ADDENDUM No. 1

ITB No. 4519

North Fifth Avenue Reconstruction

FOR INFORMATION ONLY

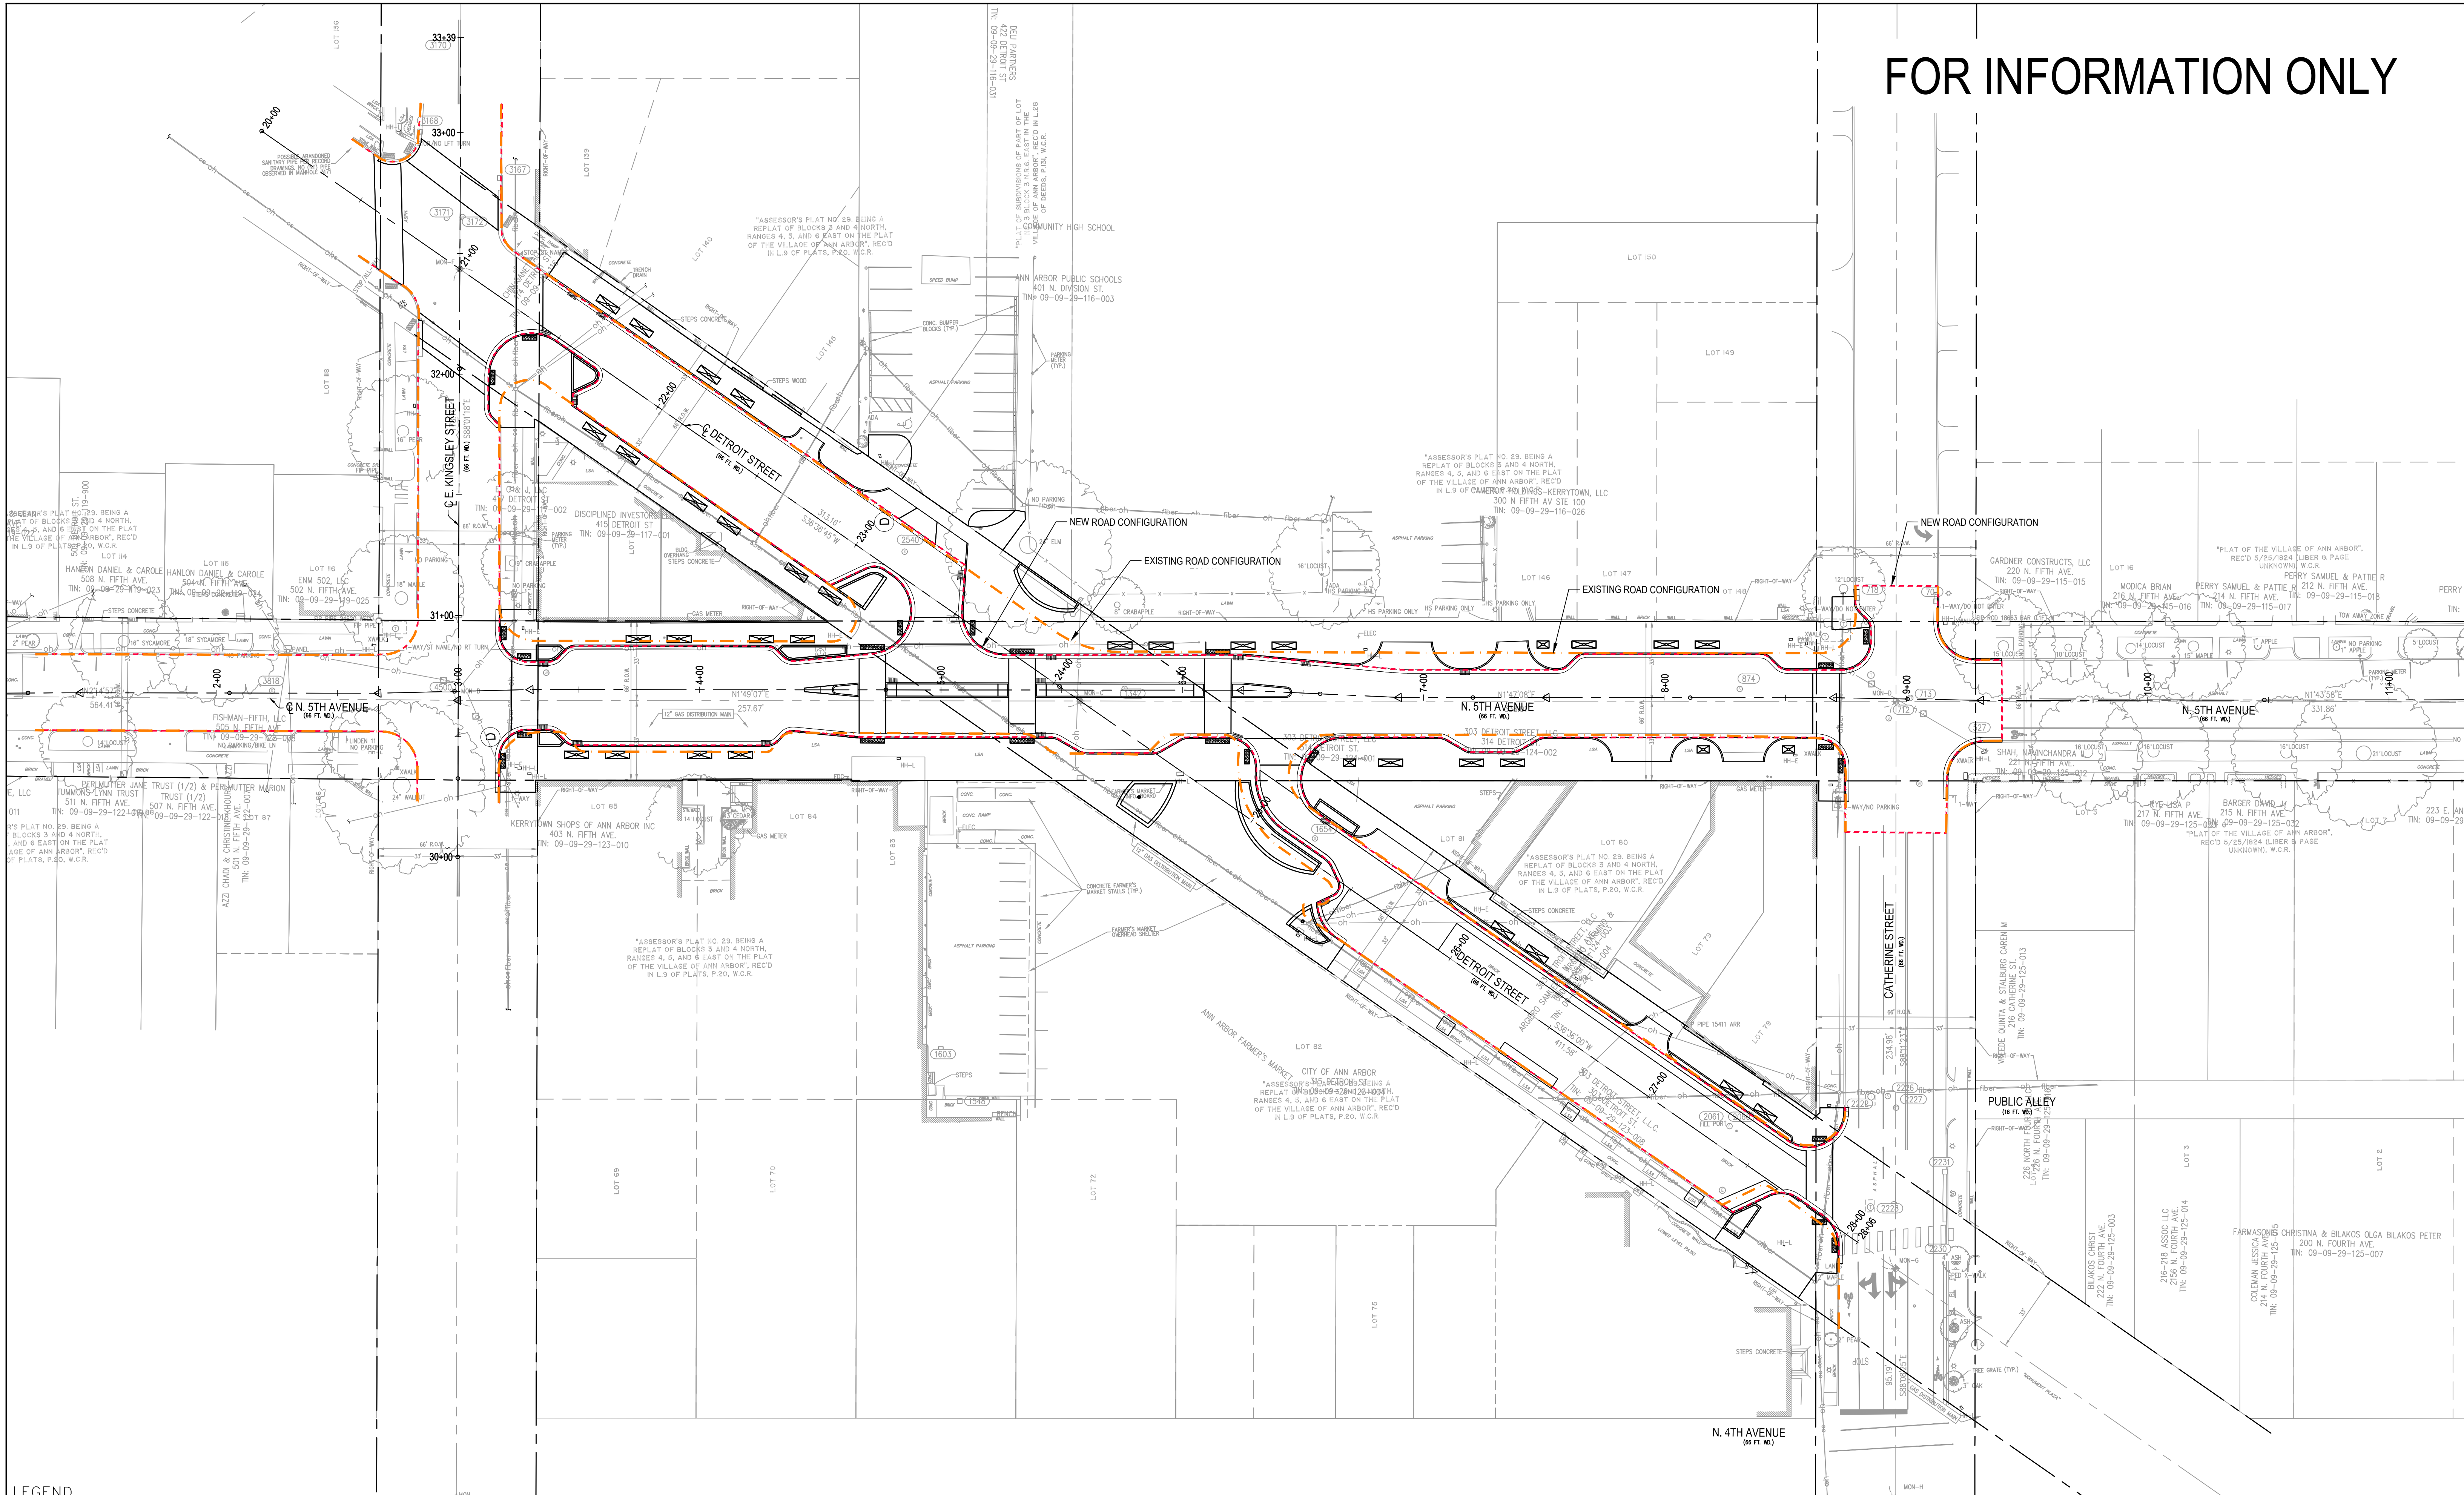
11. Would it be possible to get a drawing showing the existing road configuration overlaid with the new road configuration?
 - Response: Included in the addendum.
